**LEUPA**

**Container for low-enriched uranium**

**INDEPENDENT REVIEW OF DOCUMENT  
0908-LE01-3BEIN-024-B: LEUPA -  
CRITICALITY ANALYSIS**

**December 19, 2012**

Figure 5: Variation of the effective multiplication factor based on the mass of water retained in the Kaolite 1600

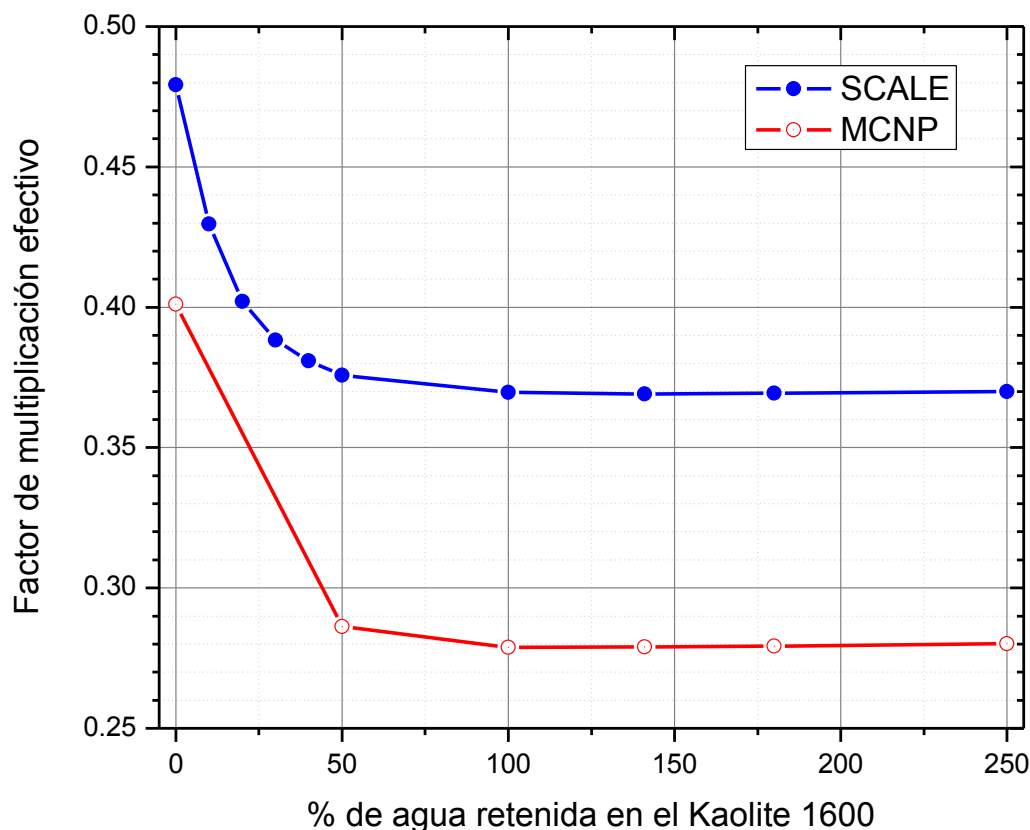
4. Figure 5 contains a graph on the values of ( $k_{\text{ef}} + 3\sigma$ ) obtained with MCNP and SCALE, based on the percentage of water retained by the insulation.
5. The SCALE calculation confirms that the most unfavorable situation from the criticality standpoint is the case of dry heat insulation, as stated in [2].

Figure 6: Variation of the effective multiplication factor based on the density of water entering the empty spaces inside and outside the package

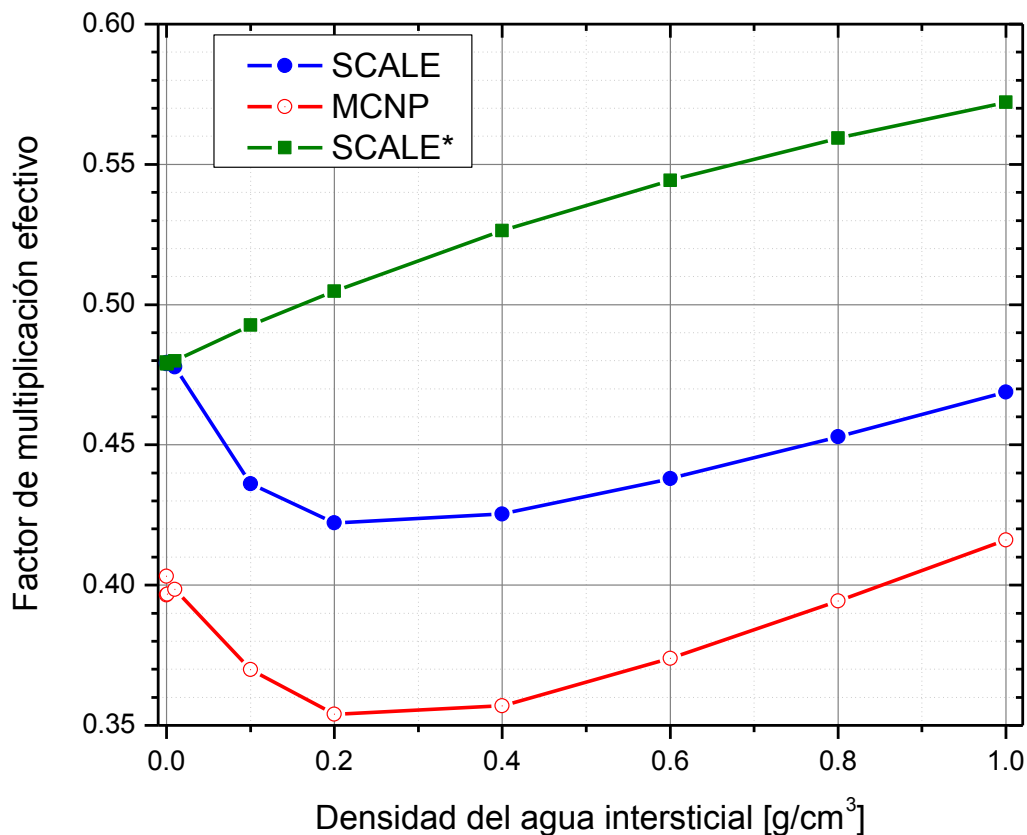
5. Figure 6 shows the values calculated with MCNP (red curve, empty circles) and SCALE (blue curve, solid circles). The existence of a minimum based on the density of the water

entering the package suggests the presence of phenomena competing among them in relation to the reactivity of the system. In order to identify and separate these phenomena, another series of calculations was prepared, where the inflow of water to the package was simulated, but only to empty spaces located within the confinement system. In other words, we simulate a scenario where there is water inflow only through empty spaces located on the inside of the cadmium cover. The results obtained are shown in the last 3 columns of Table 3, under the heading "SCALE\* (H<sub>2</sub>O confinement only)".

- The curve indicated as "SCALE\*" (green curve) in Figure 6 shows that the more reactive case is that where the water inflow only to the existing empty spaces inside the cadmium cover is simulated. This water provides moderation to the sub-moderate system and therefore the multiplication factor increases with the inflow of water.
- On the contrary, when water is also added outside the cadmium cover, the additional moderation obtained does not translate into an increase of the effective multiplication factor of the system, since the thermalized neutrons in the area outside the cadmium cover are absorbed in the cadmium before re-entering the containers with fissile material.

Figure 7: Variation of the effective multiplication factor based on the mass of water entering each internal container

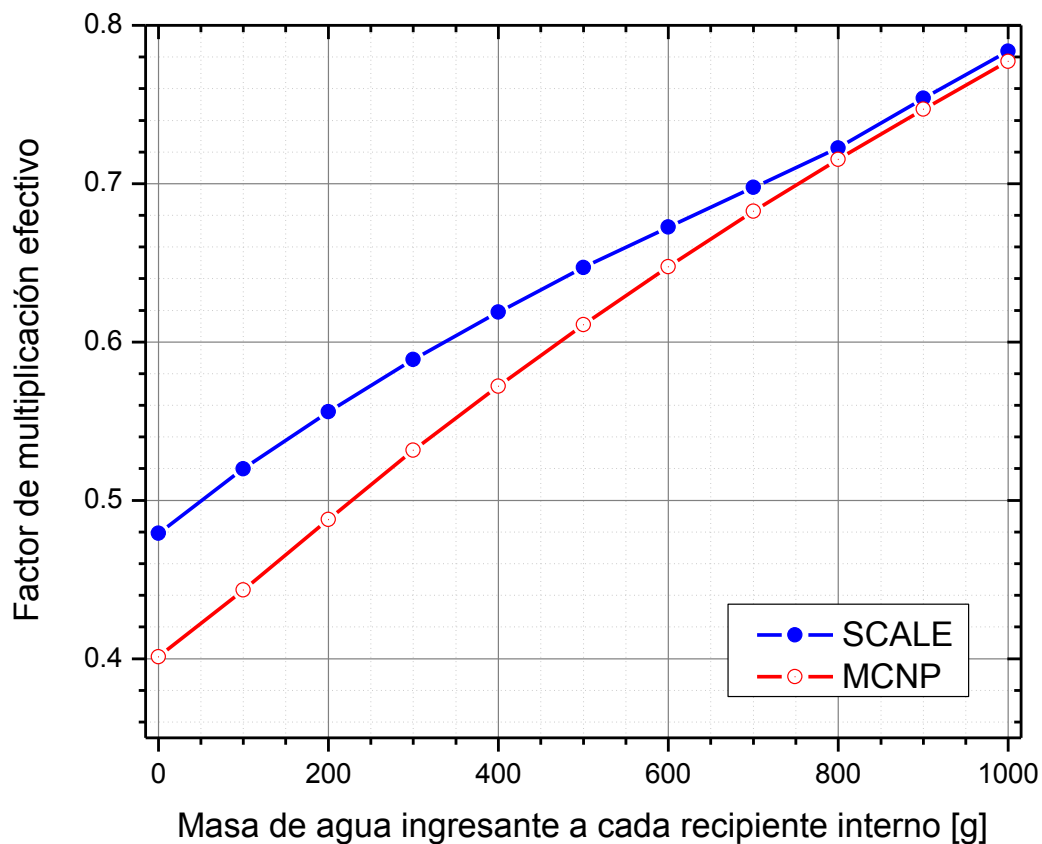
6. **Figure 7** contains the calculated values.
7. We can see that the multiplication factor increases monotonously with the water mass entering the inside container. Be it reminded that, given the measurements of the internal containers and the nominal mass of uranium metal per container, it is not possible to add more than 900 g of water per internal container.
8. In all cases, the value calculated with SCALE is higher than the value calculated with MCNP. The difference between both calculations is reduced to a minimum as the mixture of water+uranium metal modeled in SCALE fills the free volume of each interior container, since the differences in the fissile volume modeled with both codes is reduced when water is added to the container. This behavior confirms what is stated in section 7.4.1, paragraphs 3 to 6.

Figure 8: Variation of the effective multiplication factor depending on the density of water entering the gaps in the packages arrangement, when the insulation is dry

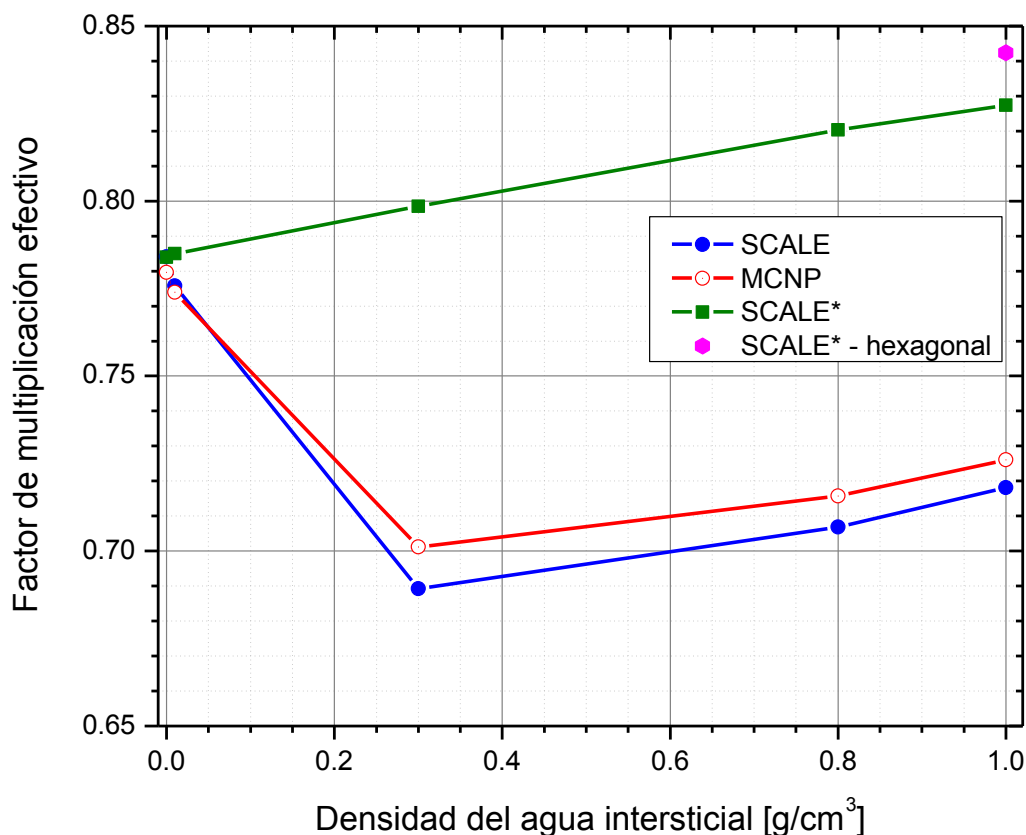
11. It is precisely in this group of cases calculated with SCALE where the more reactive case is identified: internal containers flooded with water (1000 g water per container), dry thermal insulation, and maximum density of water in empty spaces located inside the confinement.

12. Cases resulting in the maximum  $k_{\text{ef}}$  obtained with MCNP and SCALE are highlighted in **Table 5**.
13. **Figure 8** contains a graph of the results obtained with MCNP and SCALE, for cases where the insulation is dry, for different densities of water entering the gaps (homogeneous inflow of water in all the gaps of packages, and inflow of water only to the gaps located to the interior of the confinement, indicated with the label "SCALE \*" in **Figure 8**).

14. In all those cases, a square arrangement of packages was simulated in the system. Figure 8 also shows a calculation point that corresponds to the simulation of an hexagonal arrangement of packages in the system ( $k_{\text{ef}}+3\sigma = 0.84234$ ).

Figure 9: Multiplication factor depending on the density of the interstitial water, for different cases in which cadmium did not infiltrate into the cadmium chamber

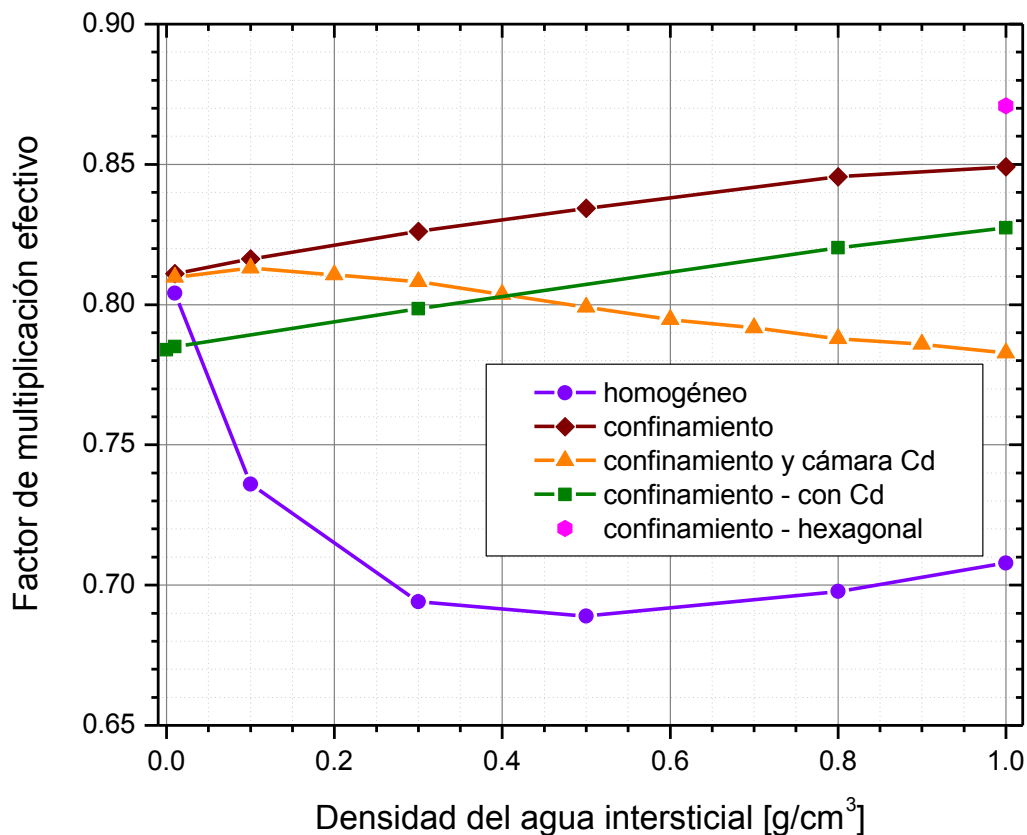
9. The curve displayed in Figure 8 is repeated in Figure 9 when water enters only the interior of the confinement (curve labeled as "confinement - with Cd"), for the sole purpose of making the effect of removing the cadmium from the cadmium cover visible.

10. In all those cases, a square arrangement of packages was simulated in the system. Figure 9 also shows a calculation point that corresponds to the simulation of an hexagonal arrangement of packages in the system ( $k_{\text{ef}}+3\sigma = 0.87083$ ).

11. It can be seen that, again, the worst case is the one in which internal containers are flooded with water (1000 g of water), the insulation is dry, water enters only into the gaps within the confinement, and the density of water in these empty spaces is equal to  $1 \text{ g/cm}^3$ . This case, which yielded the highest effective multiplication factor of all those evaluated so far, shows that even under the hypothesis of this accidental case, the subcriticality of the packages system is assured with one sufficient margin.
